## REGULAR MEETING AGENDA

**F1. Use Permit/Tali Ariely/328 Trenton Way:**

## 328 Trenton Way – Attachment A: Recommended Actions

drawing  
PROPOSED ELEVATIONS

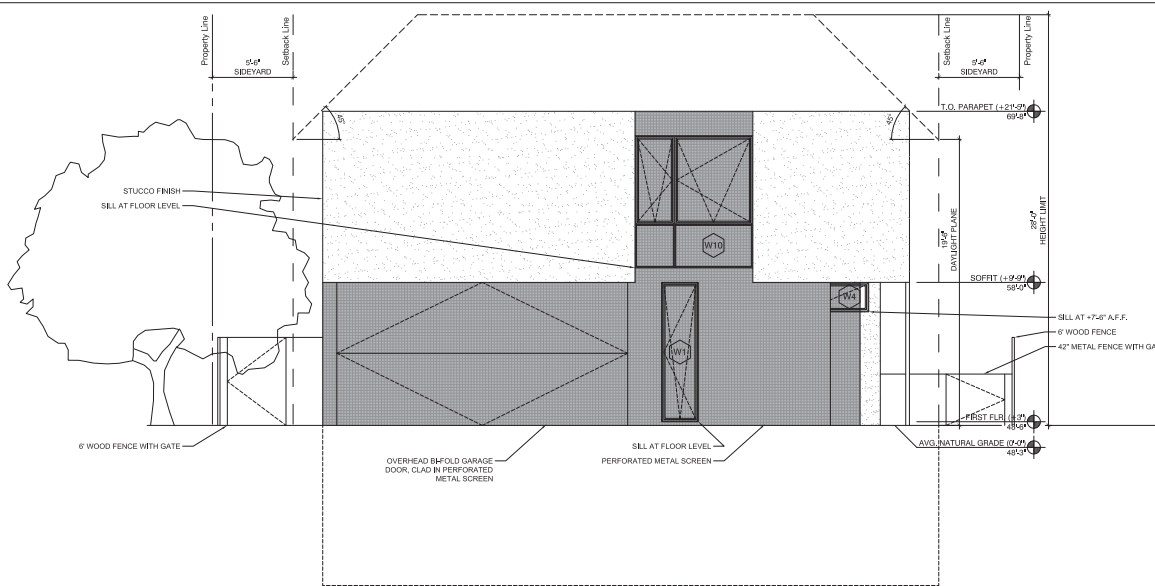
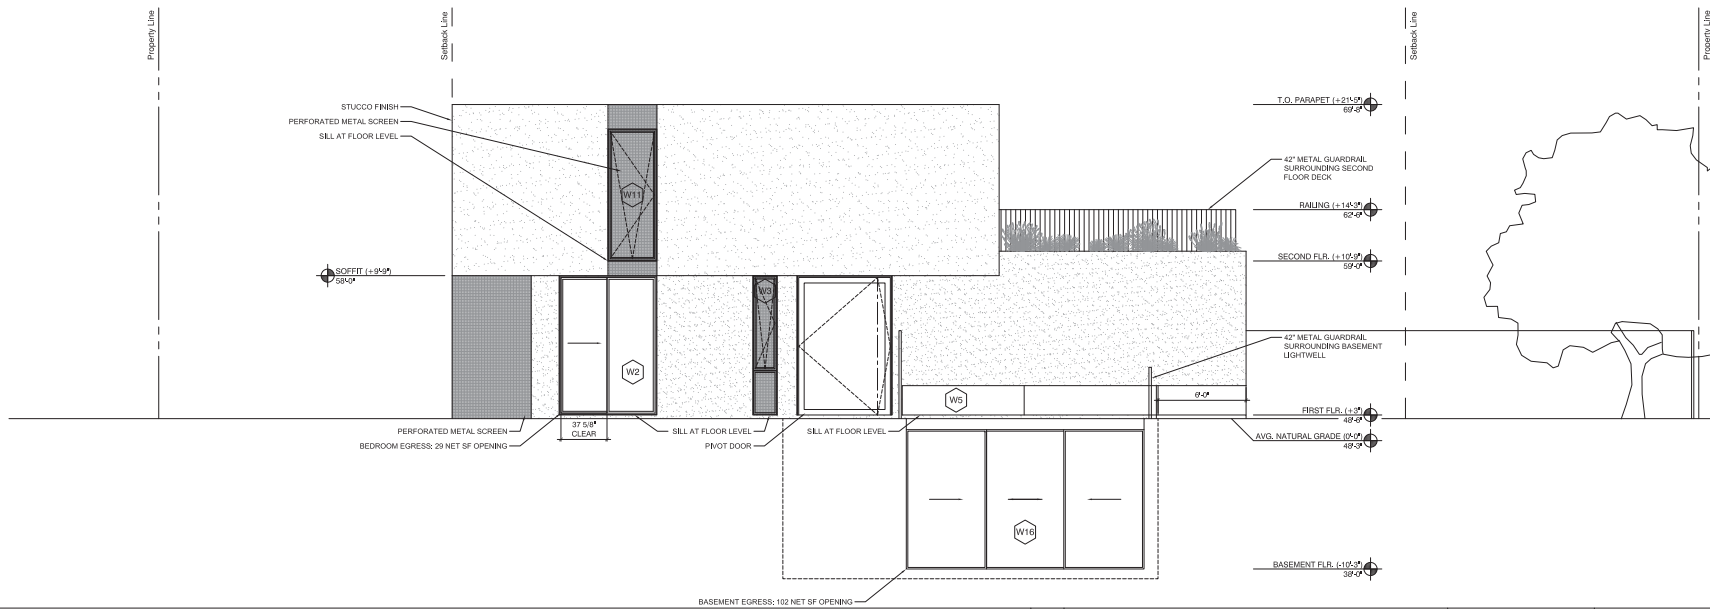
We are residents of 347 Trenton Way, which faces the proposed new construction. While we understand the need to expand living space, we feel the proposed design is out of character with the existing homes on Trenton Way and the Willows, even when considering other newer homes with a more modern aesthetic. Our strong preference would be for a house more in keeping with the neighborhood, with a design that is not as imposing from the street. If we understand the submitted plans correctly, the exterior of the home is to be stucco and perforated metal screening. A softer, less "box-like" facade with more variation would be more in keeping with the neighborhood, together with using materials that are less industrial in nature than the proposed metal screening.

We were initially quite excited when we heard that the plans would be for a modern house. When we saw the plans and rendering, however, we were appalled. The facade is essentially a 20x40ft featureless barricade composed of perforated metal and blank stucco; the current design seems to loom towards the street like a cheaply erected industrial wall that is meant to keep people out. Without any windows or doors (and coupled with the 20' setback) this facade gives an imposing vibe---completely counter to the otherwise friendly vibe of the other houses and gardens in the area. [Adding large windows to the two bedrooms at the front might help make this look more like a house and less like a high security parking garage, though the choice of the perforated metal would still be an issue.]

As stated earlier, recommended conditions of approval are included as Attachment A, in case a majority of the Planning Commission votes to approve the project. Since the metal screening may not provide the desired level of privacy screening, staff has added recommended condition of approval 4(a), requiring the use of frosted glass for the portions of all windows above the first floor but below a point 42 inches above the finished second floor, to match the frosting proposed by the applicant for the windows along the rear elevation.

drawing  
 PROPOSED RENDERING

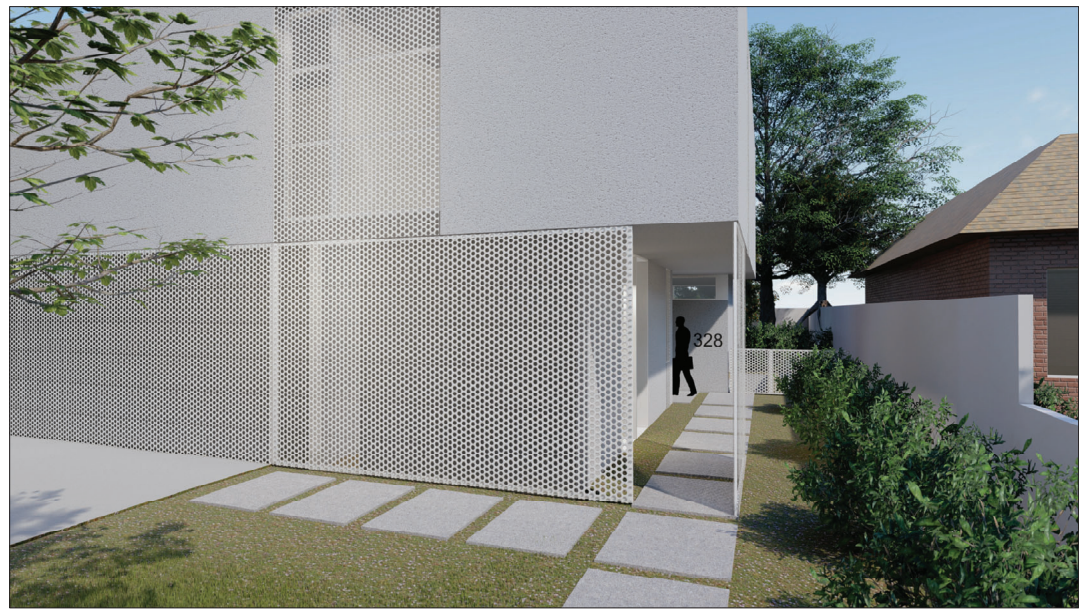
Secondly, I would like to formally complain about the style of the house. I have seen the actual plans and the computer illustration of the proposed house. It has a very cold, boxy, commercial appearance that is radically different from any house on our street, or in the entire Willows neighborhood for that matter. I sincerely hope the owners will reconsider the design and choose a style that complements our neighborhood.
